**STAFF REPORT**  
**COMMUNITY DEVELOPMENT DEPARTMENT**

SUBJECT: Brundage Estates Subdivision No. 1  
FP-2024-0024

Final Plat consisting of 29 residential building lots and six (6) common lots on approximately 11.62 acres of land in the R-4 zoning district by L.C Development.

B. Final Plat (dated: 10/18/24)

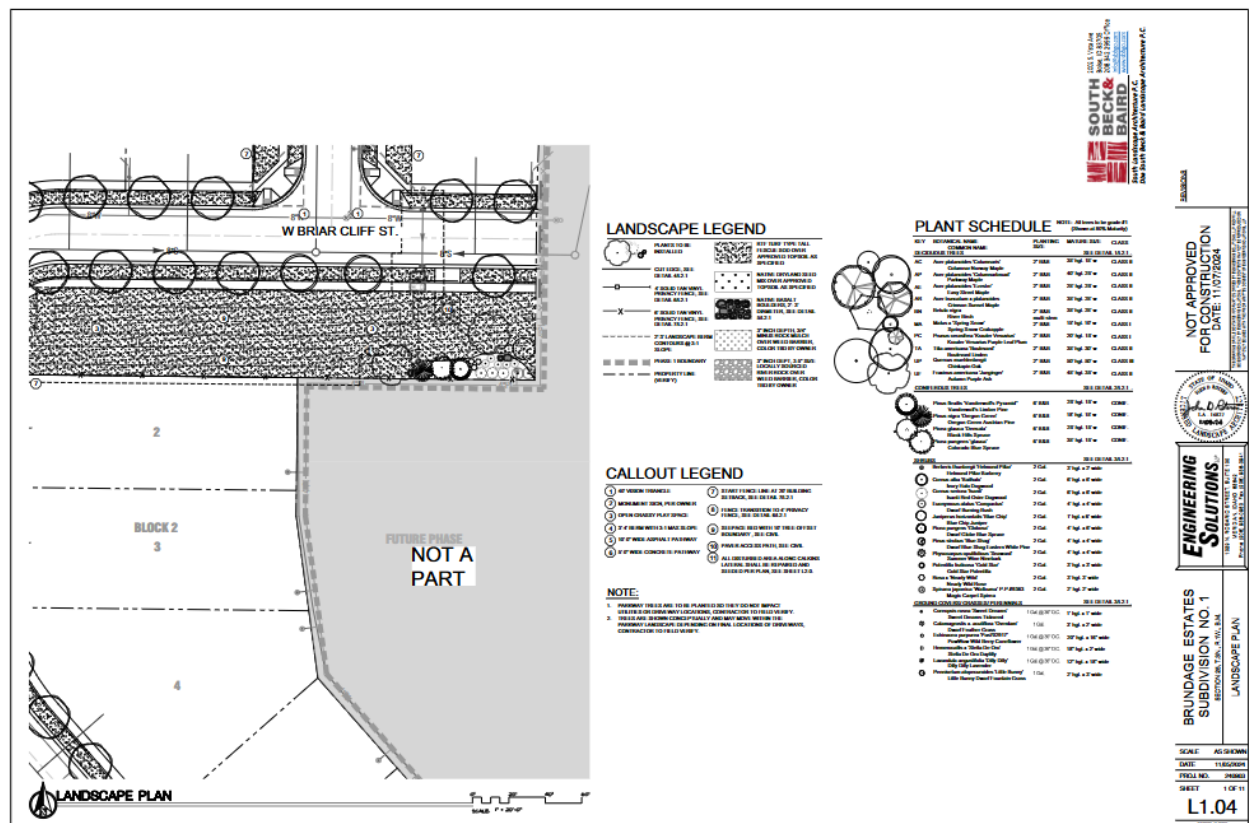
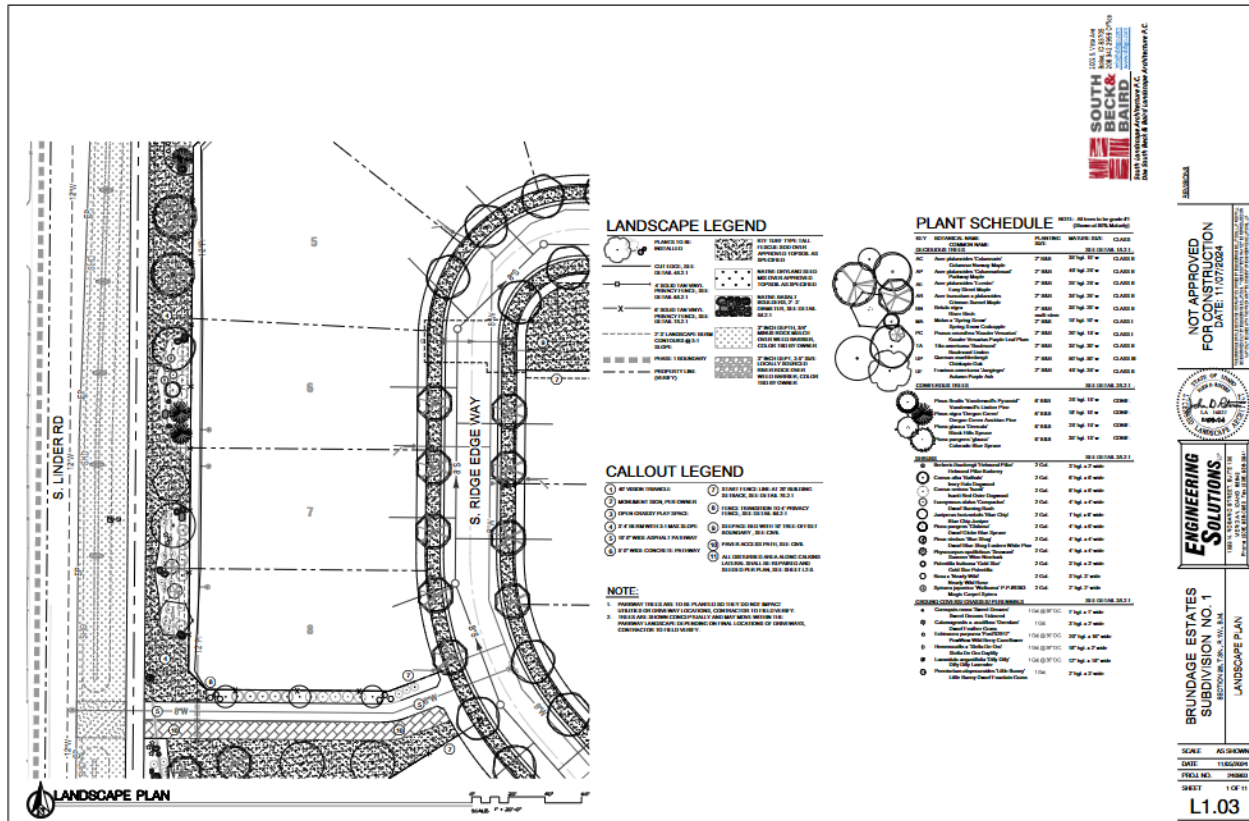
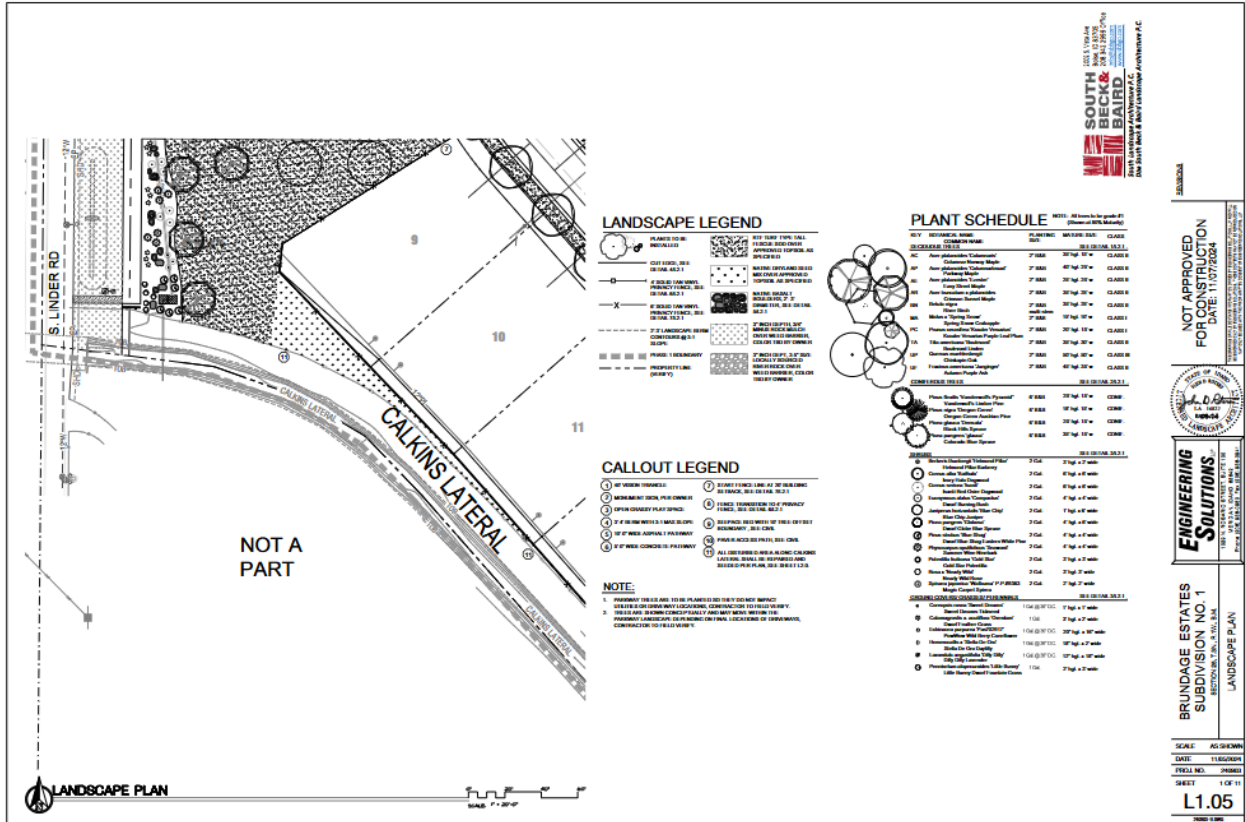
*An electronic copy of the revised plat shall be submitted prior to signature on the final plat by the City Engineer.*
